**VENETA
PLANNING COMMISSION
STAFF REPORT**

**Hillbilly Brews Expansion – City File No. SR-4-23
Site Plan Review**

**FINAL ORDER
OF THE
VENETA PLANNING COMMISSION**

**Hillbilly Brews Expansion Site Plan Review
(File No. SR-4-23)**

Exhibit B

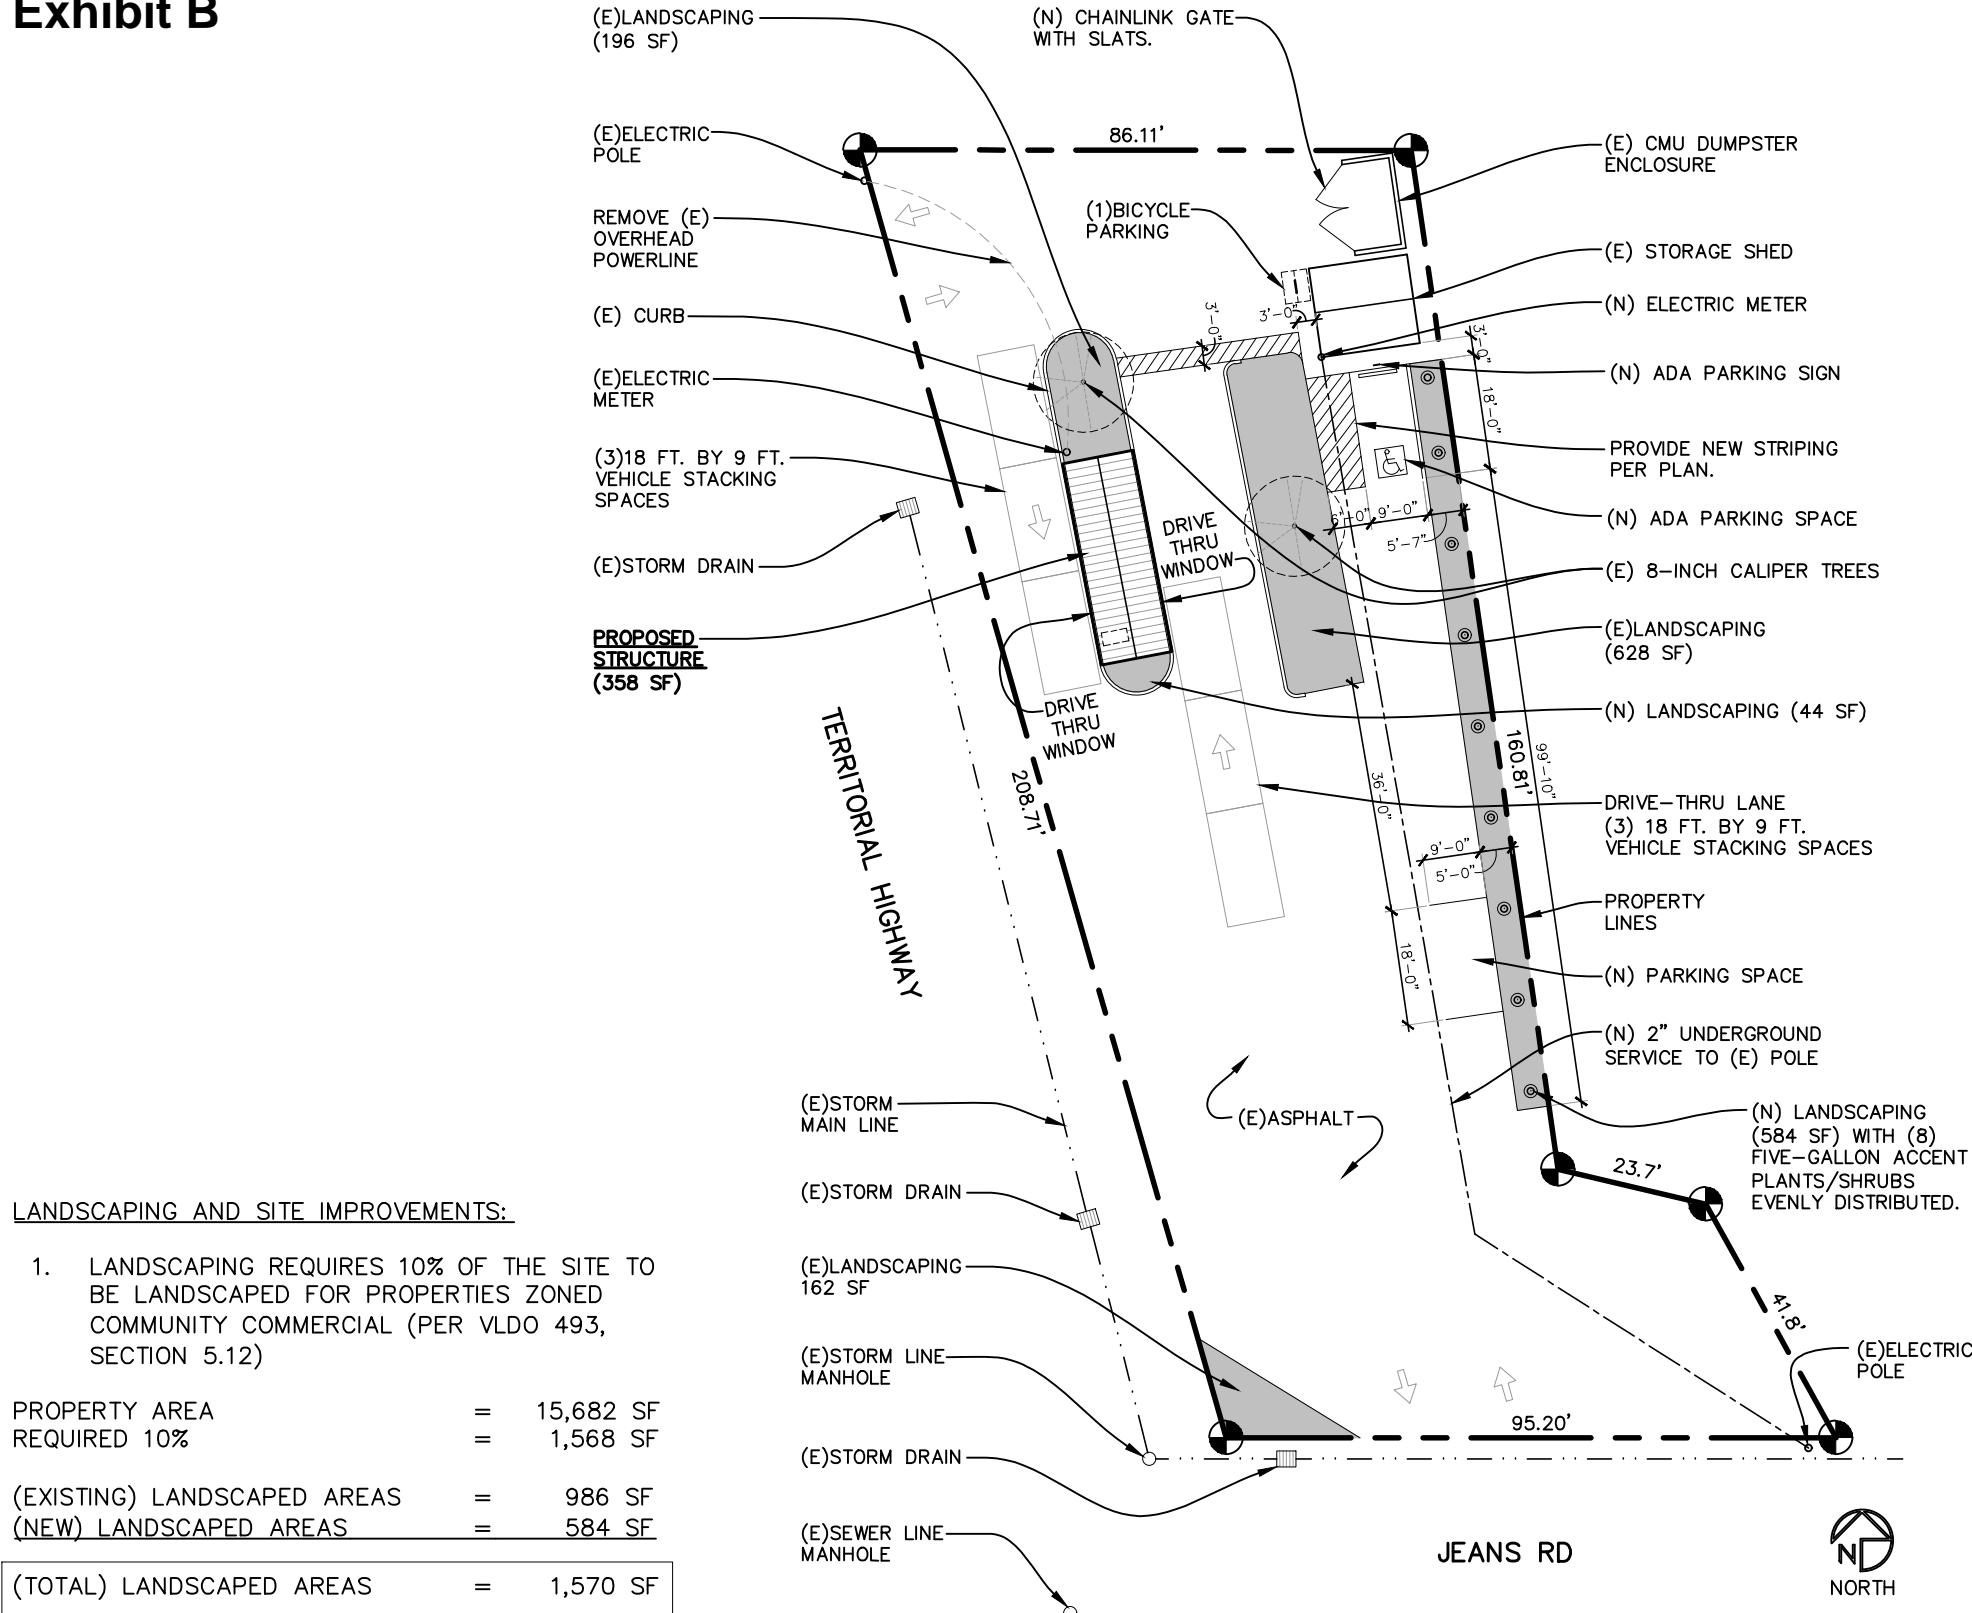
This means access from Territorial Highway would need to be closed and the only access to and from the property would be from Jeans Road. In recognition of this being an established operation that does not have a documented history of safety concerns, and the fact that this proposal will not add a significant number of additional trips, Lane County would be willing to allow the Territorial Highway access to remain open with modifications to the Jeans Road access. Modifying Jeans Road to be right in/right out only would satisfy concerns the County has about this access location. Specifically, there are concerns surrounding turning movements both into and from the property because of the proximity to the Territorial Highway and Jeans Road intersection. Signage and pavement marking would be an acceptable remedy to modify the access.

- Per LC 15.137(3), in order to retain the second access, located on Territorial Highway, signage and pavement markings must be added to the Jeans Road access indicating that this access is only right turn in and right turn out.

The City Engineer's findings stated that "the ADA parking stall needs to be a van-accessible stall per ORS 447.233 with a 9' wide stall and an 8' wide accessible aisle..." The proposed ADA-accessible parking space on the applicant's site plan shows an 82" (or 6' 10") wide van-accessible stall at its widest, with the stall narrowing down to 6' as it travels south. A condition of approval has been added to ensure that the applicant provides a stall in accordance with ORS 447.233 and Table 5.20(c) of the Veneta Land Development Ordinance No. 493.

Findings: The lot does not abut a residential zone, therefore, subsections A and B do not apply. The applicant's site plan shows a 5-foot setback for the two off-street parking spaces. Landscaping will be discussed further under the findings for Section 5.12. No additional setbacks are needed according to Section 5.09, and no future right-of-way is currently needed along Jeans Road or Territorial Road.

Findings: 1,995 square feet of landscaping will require a minimum of 2 trees and 8 five-gallon shrubs or accent plants. There are two existing 8-inch caliper trees on-site. The applicant proposes to plant 8 five-gallon shrubs in the proposed landscaping strip along the east property line. A condition of approval has been added to ensure that the site is landscaped according to the standards of Section 5.12(4), and to the standards of Section 5.12 in general.

Findings: There is an existing garbage enclosure at the northeast corner of the site. The applicant is proposing to install a new chain link fence with sight-obscuring slats at the entrance of the garbage enclosure. A condition of approval has been added to ensure that this standard is met.

6. Per LC 15.137(3), in order to retain the second access located on Territorial Highway, signage and pavement markings must be added to the Jeans Road access indicating that this access is only right turn in and out.

8. Prior to issuance of a Certificate of Occupancy, the applicant shall plant groundcover species in accordance with Section 5.12(5) of the Veneta Land Development Ordinance No. 493, plant eight five-gallon shrubs or accent plants in accordance with Section 5.12(4) of the Veneta Land Development Ordinance No. 493, and shall install irrigation to the new landscaping in accordance with Section 5.12(6) of the Veneta Land Development Ordinance No. 493.

9. Prior to issuance of a Certificate of Occupancy, the applicant shall install a chain-link fence with sight-obscuring slats at the entrance of the existing garbage enclosure in accordance with the approved site plan and Section 5.12(8) and Section 5.12(9) of the Veneta Land Development Ordinance No. 493.

**SHEET: A4
ELEVATIONS
5 OF 8 SHEETS**

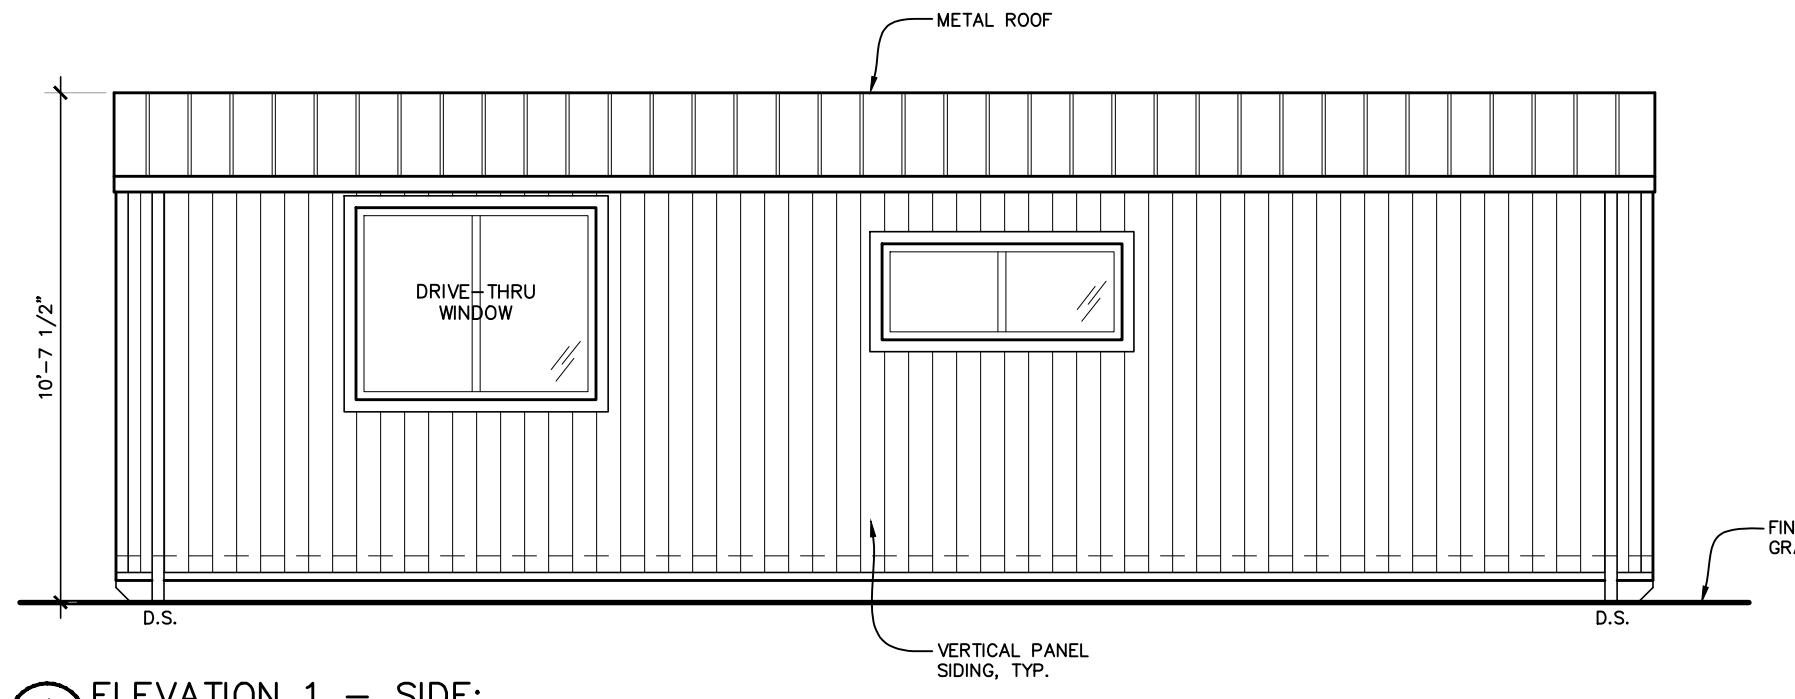
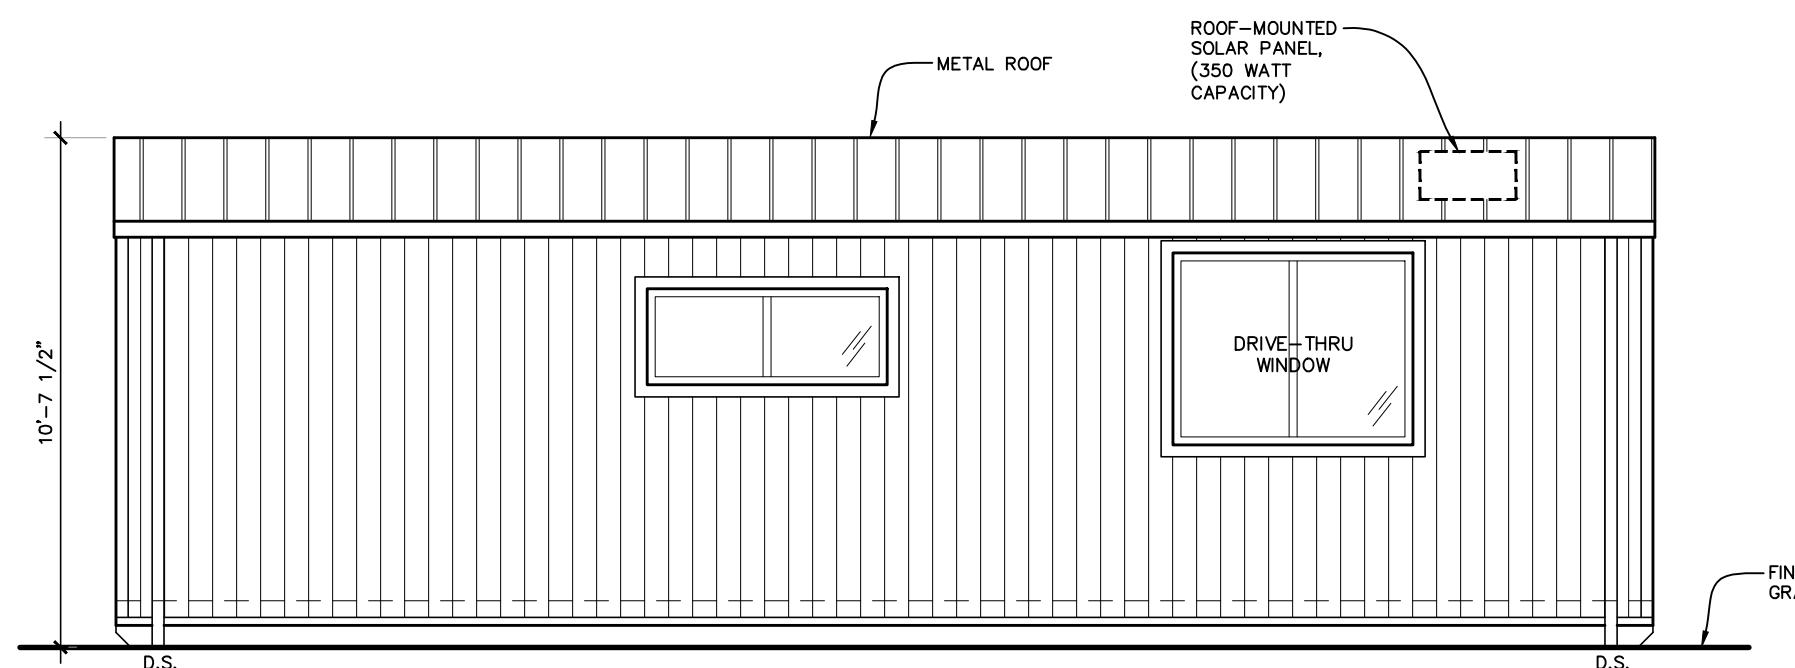
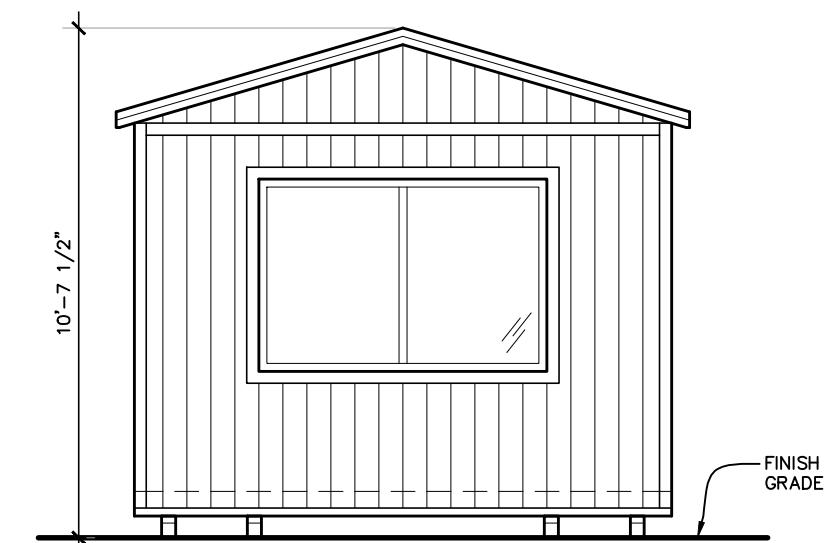
Section 5.13(2)(C) requires that all primary building entrances incorporate a pedestrian shelter. This can be achieved through features like recessed entrances, porches, stoops, overhangs, or other similar features. The proposed building does not contain a pedestrian shelter. However, this building is drive-through only, and is not open to the public. The applicant is requesting that the Planning Commission waive this requirement, and staff recommends the Commission do so, as a pedestrian shelter is not needed in this specific situation.

Section 5.13(2)(H) requires that all street-facing building elevations contain a 'break in the plane' at least once every 30 feet. This break can be achieved through building offsets, projections, overhangs, bays, arcades, balconies, dormers, towers, etc. The intent of this standard is to promote aesthetic and visual interest by breaking up large expanses of uninterrupted walls. The proposed building does not contain such a break in the plane, however, it is only 32 feet long. The applicant is requesting that the Planning Commission waive this requirement, and staff recommends the Commission do so, as the proposed building does not contain an excessive amount of uninterrupted building surface, and only slightly exceeds the 30-foot requirement.

Subsection (2)(H) requires a 'break in the plane' on any street-facing building elevation longer than 30 feet. The elevation facing Territorial Road is 32 feet long. The applicant is requesting that the Commission waive this requirement. The intent of this section is to provide visual interest and articulation in building elevations that would otherwise be excessively long and monotonous. Given that the entire length of the building is only 32 feet, this standard is not necessary, and this criterion is met.

Subsection (2)(I) requires that all street-facing commercial building elevations have openings covering at least 60% of the elevation. When measured as a percentage of the lineal plane, the proposed building only has 34% of its street-facing elevation covered in windows. The applicant is requesting an adjustment to accept this amount of window coverage. The intent of this section is to provide visual interest to the streetscape and to encourage a kind of natural surveillance of the street from the interior of buildings. However, the employees will consistently be at the drive-through window, allowing a natural surveillance of the street. Additionally, the building is fairly small, meaning a smaller percentage of windows will not significantly affect the aesthetics of the building as it otherwise might in a larger building. For these reasons, this criterion is met.
